Revised Chassis Grounding for the Freedom Marine Inverters

Errata

976-0122-01-01 Rev A

This Errata contains changes to the grounding section of the Freedom Marine manual: 445-0194-01-01 Revision 2.

Chassis Grounding

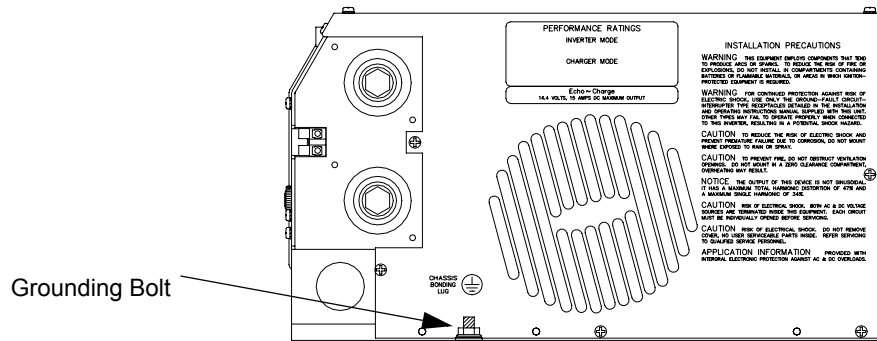
The chassis ground connection to the inverter, which is also known as the DC ground in the marine industry, has changed to improve connectivity.

The chassis ground lug on the inverter has been removed. This has been done for several reasons, but the most important reason is to improve connectivity.

There is now a $\frac{3}{4}$ inch circular area around the bolt that is free of powder coat. The bolt, a stainless steel washer and a serrated nut will be included with the inverter, however you will need to provide a ring terminal or other ABYC-compliant lug to ground the unit.

According to ABYC, the copper lug of the cable can't be placed in direct contact with an aluminum surface, however, a stainless steel washer may be placed in between the lug and the chassis.

The order of the hardware installation should be:

1. Chassis of the inverter
2. Washer
3. ABYC-compliant grounding lug
4. Serrated nut

Please torque the nut to 85 inch pounds.
